C02241

RE: Tree Planter Amendment – Bassendean Hotel Development Project

This letter is to be submitted as an addendum to the previously supplied AIA (Arboricultural Impact Assessment – C92145 – 2020) as pertains to the Bassendean Hotel site.

Figure 1. Excerpt from Finishes Plan LA-02-03 – tree numbers added by author. (16 June 2021).

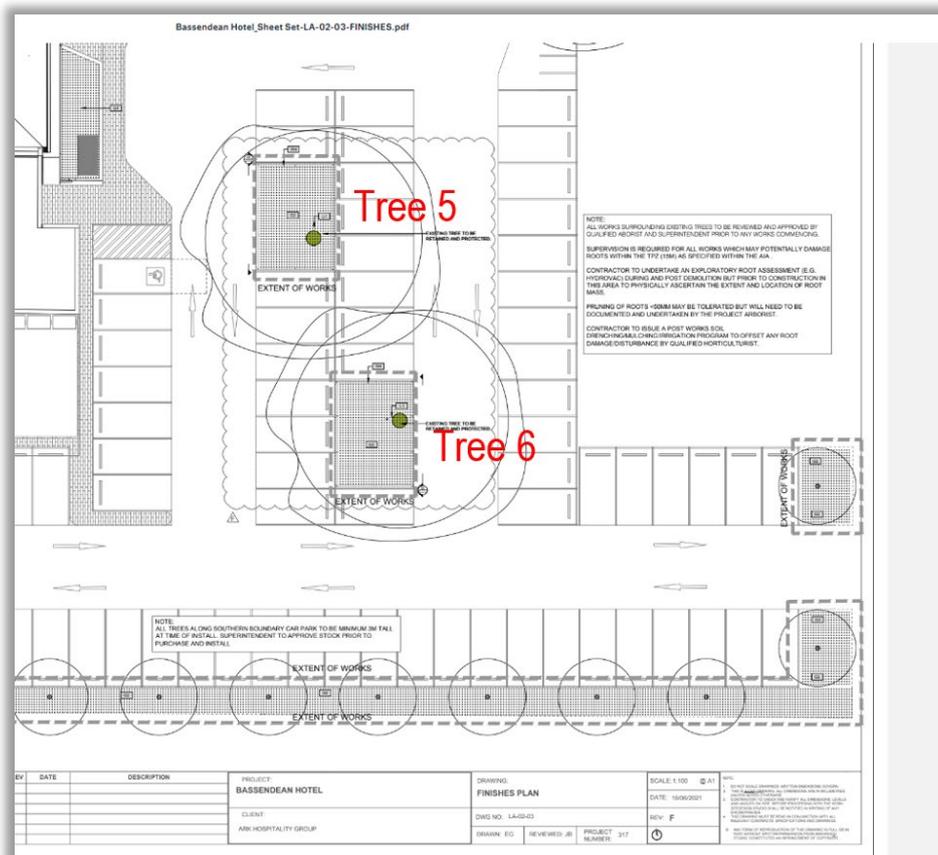
Proposed Planter Design (Amendment) – Trees 5 and 6

Trees 5 and 6 (see Figure 1) were documented in the site’s AIA as mature examples of *Ficus microcarpa* var. *hillii* (Hill’s Weeping Fig). Both trees were estimated to have radial TPZ’s (Tree Protection Zones) of between 12–15m, with noted signs of extensive root activity (and associated seal/surfacing damage) throughout the original carpark area.

In order to retain Trees 5 and 6 and to limit the potential impacts of the proposed development, it was determined that subsoil excavation, within the respective TPZs of Trees 5 and 6, would need to be limited and that open/slot trenching should be avoided entirely.

Figure 2. Excerpt from Typical Planting Details, LA-04-05. (16 June 2021).

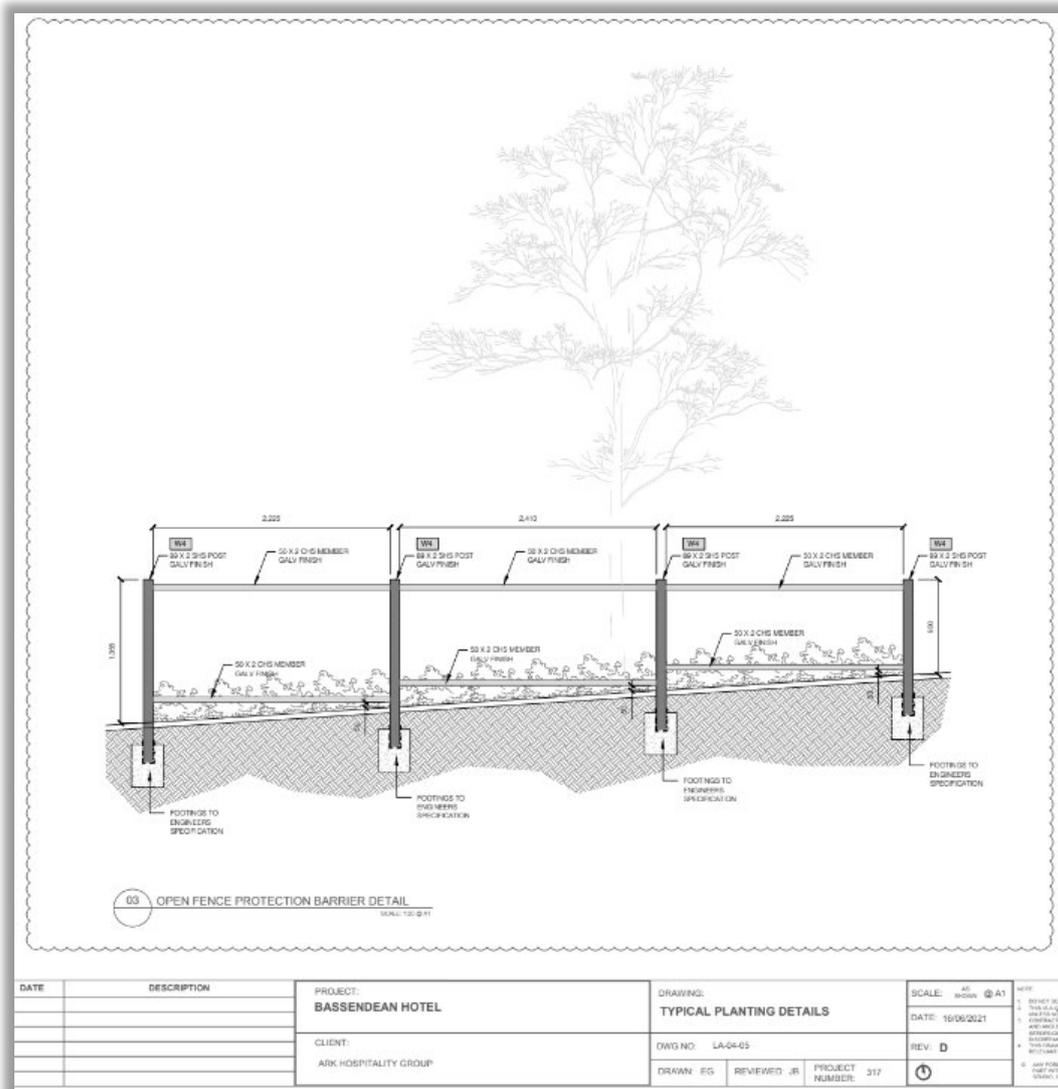
As an alternative to slot trenching, as would be associated with preparation works for garden bed retaining walls, the installation of a post and rail configuration has been proposed (see Figure 2). This physical delineation methodology will allow for minimal excavation within the TPZs of Trees 5 and 6, whilst meeting other relevant design brief criteria.

Where proposed footing (excavation) works (as per *Open Fence Barrier Detail – LA-04-06*) are located within the documented TPZs of Trees 5 and 6, and as such represent a TPZ encroachment (refer to Section 6 of the AIA), the proposed encroachment shall be considered acceptable where;

- Other relevant generic tree protection measures (as listed in Section 7 of the AIA) can be met and;
- Where all proposed excavations within the TPZ are undertaken in a root sensitive manner (e.g. manually dug and/or through the use of a hydrovac/air spade) and;
- Are undertaken under the direct supervision (or with the expressed consent) of the project arborist.

Where the project arborist deems that excessive root damage will occur as associated with the above excavations, footing relocation and/or repositioning may be required.
